NEDO-33006-A - Non-proprietary

NEDO-33006-A REVISION 3
NON-PROPRIETARY VERSION

APPENDIX A: GEH RESPONSES TO NRC RAIs

Figure 17-1 BSEP 1 and 2 MELLLA+ Operating Range Power-Flow Map (NEDC-33063P)

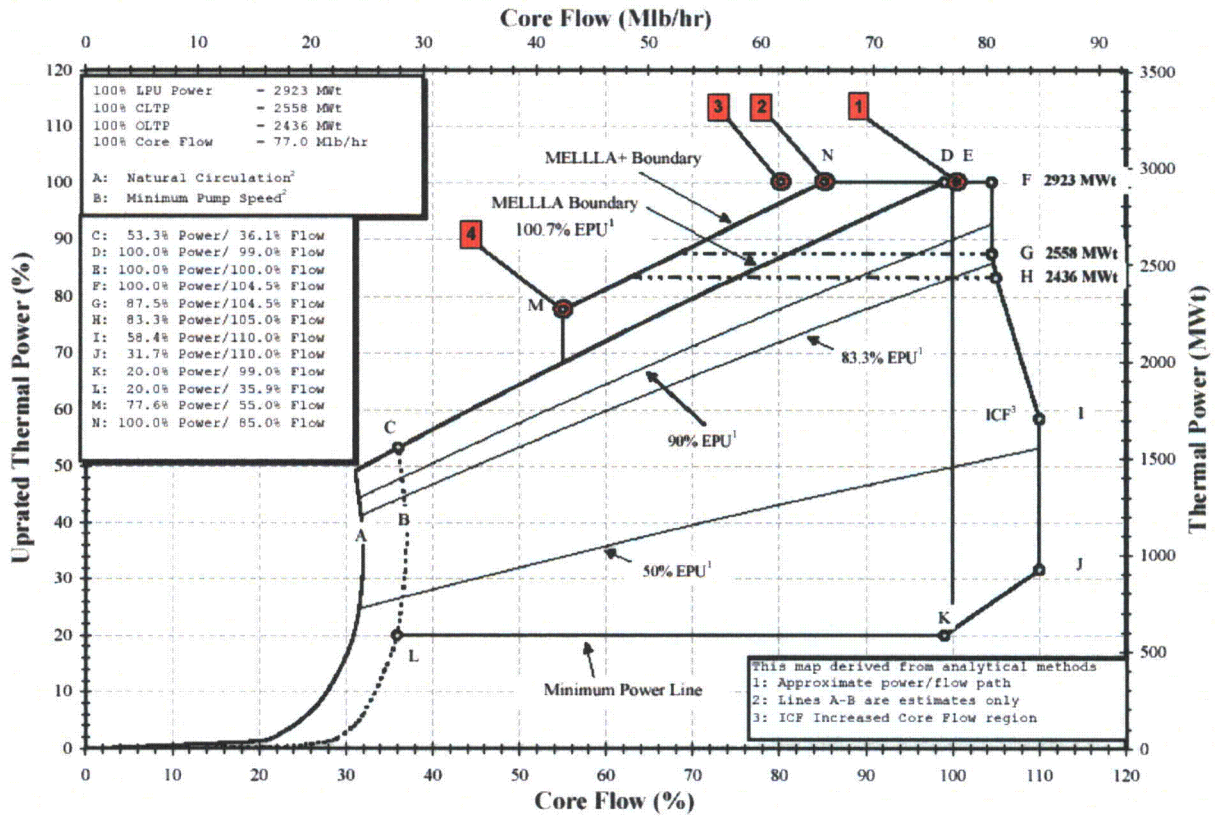
Case (1) was the rated condition (state point "E" in Figure 17-1) SLMCPR evaluation that was used in the Reload Licensing Analysis for Brunswick 1 Cycle 15. Case (2) determined the

SLMCPR for the rated power / lowest licensed flow condition (state point “N” in Figure 17-1). Case (3) determined the SLMCPR for rated power / lowest flow for the generic MELLLA+ application, for comparison purposes. Case (4) determined the SLMCPR for the highest off-rated power / lowest off-rated flow statepoint along the Brunswick 1 MELLLA+ upper boundary (point “M” in Figure 17-1).

Cases (2) and (4) correspond to points N and M, respectively, on the MELLLA+ boundary, as seen in Figure 17-1. The SLMCPR calculations for these two cases used a fixed set of control rod patterns for a given exposure point calculation, as shown in Figure 17-2. This was done to illustrate the impact to SLMCPR when moving between state points M and N along or near the MELLLA+ boundary line without the effects of changing the limiting control rod configuration, which is typical of plant operation following control blade maneuvers which are performed at off-rated conditions.

Figure 1-1 MELLLA+ Operating Range Power/Flow Map

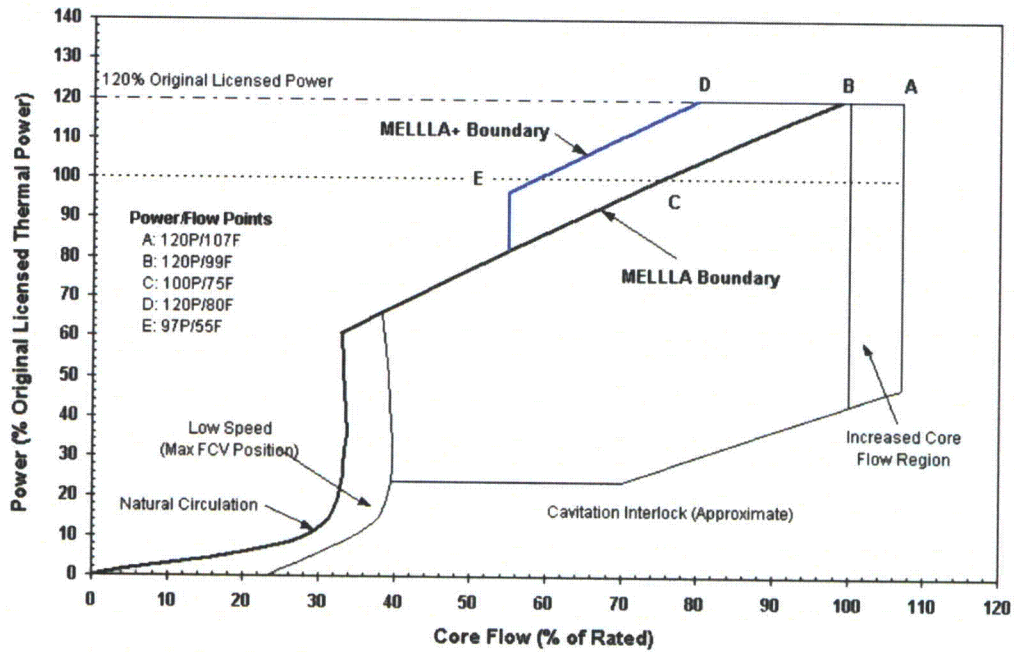
Figure 1-1 of this SE shows a power-flow map for a typical BWR. BWRs operating at the OLTP typically operate in a power-flow range identified as the MELLLA range, which is characterized by the operating statepoint of reactor thermal power of 100 percent of OLTP at 75 percent flow (point C of Figure 1-1). Some plants currently combine the MELLLA operating region with increased core flow (ICF) resulting in an operating map called MEOD, which increases the power-flow range up to 107 percent flow (point A of Figure 1-1).

As seen in Figure 1-1, the flow control window in EPU reactors is very small (approximately 1 percent flow). Therefore, reactor operators are forced to either move control rods very often or allow power changes as burn-up takes place. In a typical EPU reactor, the control rods must be repositioned almost on a weekly basis to maintain power at the licensed level.

MELLLA+ attempts to address this flow control issue by increasing the operating range to point D of Figure 1-1 (120 percent OLTP, 80 percent flow); thus creating a 20 percent flow-control window. The EPU plants operating in the MELLLA+ range will require significantly lower number of control rod movements than presently licensed EPU plants. This represents a significant improvement on operating flexibility. It also provides safer operation, because reducing the number of control rod manipulations: (a) minimizes the likelihood of fuel failures and (b) reduces the likelihood of accidents initiated by reactor maneuvers required to achieve an operating condition where control rods can be extracted. However, this safety increase must be compared to other factors such as the higher power effect on transients and the fact that more channels are placed closer to limits by the power-profile flattening.

The MELLLA+ LTR will be revised to state that the MELLLA+ plant submittals will include calculations for the Appendix K and Nominal PCT at rated power/rated core flow, rated power/MELLLA+ boundary (point D of Figure 1-1), and the low flow point on the MELLLA+ boundary at which the off-rated flow dependent LHGR or MAPLHGR setdown begins to apply.

This point will be at or above 55% core flow and between points D and E on Figure 1-1 (call point E’).

Figure 2-1 Illustration of the power-flow map, showing that MELLA+ operation will result in deeper penetration inside the instability region following a two-pump RPT

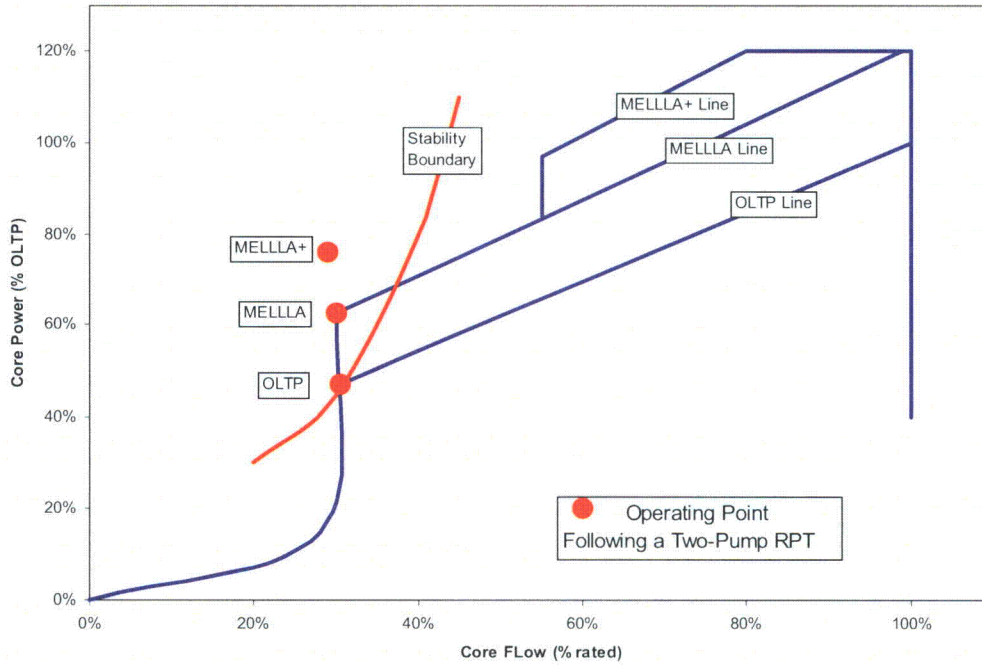
Figure 2-1 of this SE illustrates the reasons for the decrease in stability margin induced by MELLLA+ operation. This figure represents a typical reactor power-to-flow map, with a typical stability boundary line. Operation in the instability region (to the left of or above the stability boundary) can result in unstable power oscillations. As seen in this figure, when operating in the OLTP 100 percent rod line (e.g., at 100 percent OLTP, 100 percent flow), the reactor may or may not become unstable following a 2RPT. When operating on the MELLLA rod line (e.g., 120 percent OLTP, 99 percent CF), the reactor enters the instability region following a 2RPT; thus, the possibility of instability is high. When operating on the MELLLA+ line (e.g., 120 percent OLTP, 80 percent CF), the final operating point following a 2RPT is so far into the instability region that unstable power oscillations are essentially guaranteed.

Figure 2-4 Illustration of DSS/CD Defense in Depth Algorithms

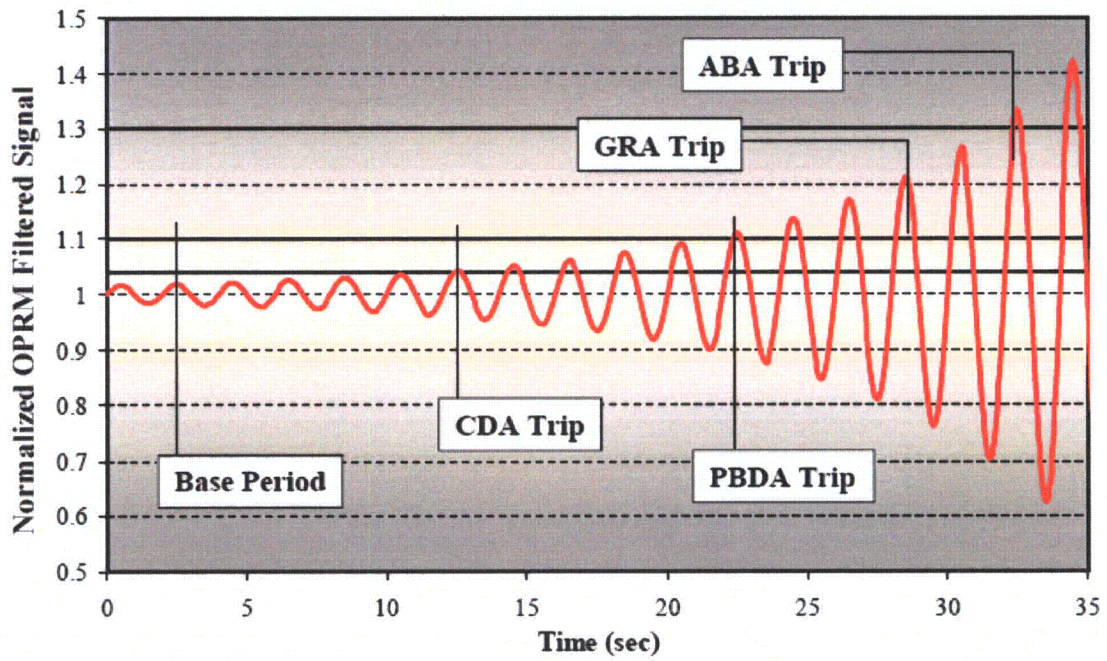
Figure 2-4 of this SE illustrates the operation of the main DSS-CD algorithm (CDA) and the defense-in-depth algorithms (PBDA, GRA, and ABA). The defense-in-depth algorithm would only be required in case the CDA algorithm failed for an unforeseen reason. They are armed when the oscillation amplitude reaches either 10 percent (PBDA and GRA) or 30 percent (ABA).

Figure 9-1 Illustration of reactor power during ATWS events from MELLLA+ and OLTP initial conditions. The final power is significantly larger under MELLLA+

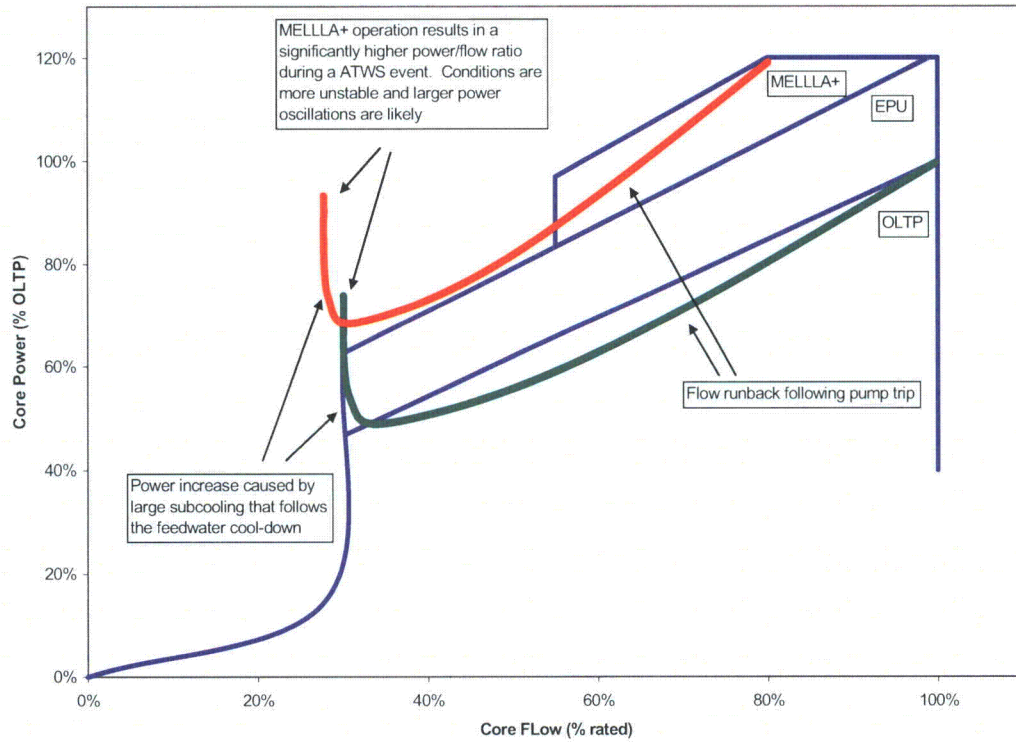
The NRC staff review indicates that, in principle, MELLLA+ operation affects ATWS-Stability. Operation in the MELLLA+ corner (120 percent OLTP, 80 percent CF) results in the reactor settling at significantly higher power, following a RPT, than the event initiated at rated OLTP condition. This higher power makes the final power even larger after the feedwater cool-down period. Thus, at least in principle, the unstable power oscillations are enhanced under MELLLA+, and their consequences should be more severe. This effect is illustrated in Figure 9-1.

Figure 9-8 Reactor power calculated by TRACE for isolation ATWS.

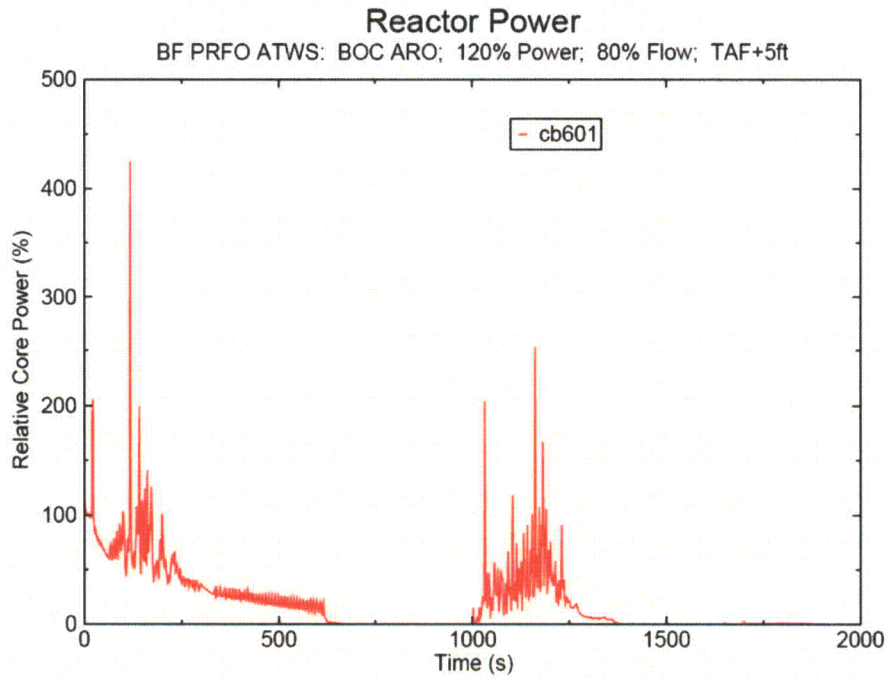
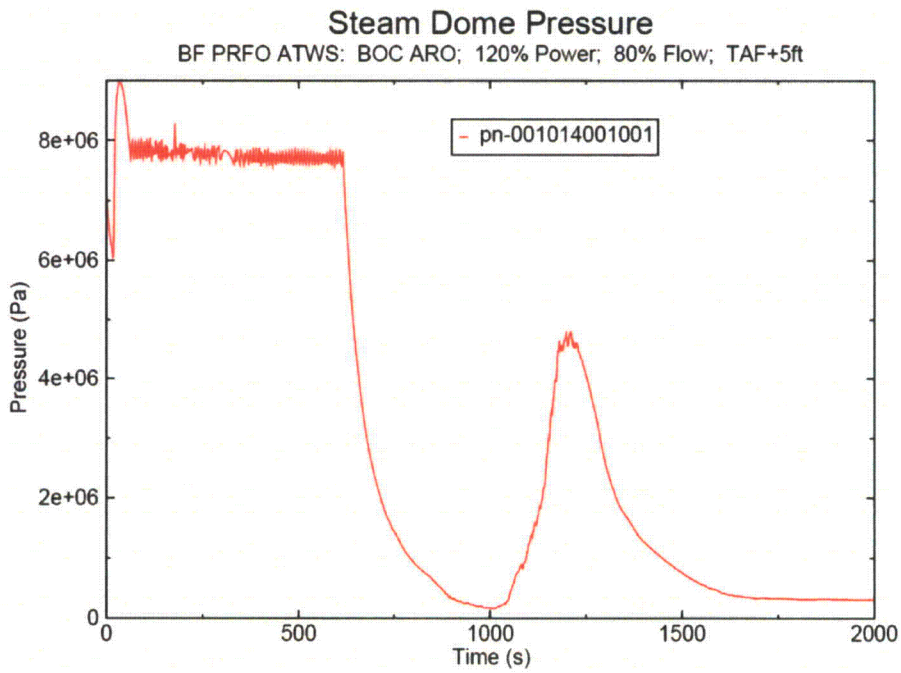
reactor shutdown. During this period, the power level oscillates wildly, and it reaches spikes as high as 200 percent OLTP, with an average of 50 percent to 70 percent. See Figure 9-8 and Figure 9-9 of this SE. The HCTL and emergency de-pressurization start at approximately 600 seconds. Following the emergency de-pressurization, the reactor becomes critical and the pressure recovers. Following a short closure to maintain pressure above 50 psi at time approximately 1000 seconds, all SRVs are open during the re-pressurization event at time approximately 1100 seconds. The calculated suppression pool temperature indicates that containment limits would have been violated in this transient (see Figure 9-10). The HCTL is reached in ~600 seconds. The final pool temperature for the TRACE calculation is approximately 240°F.
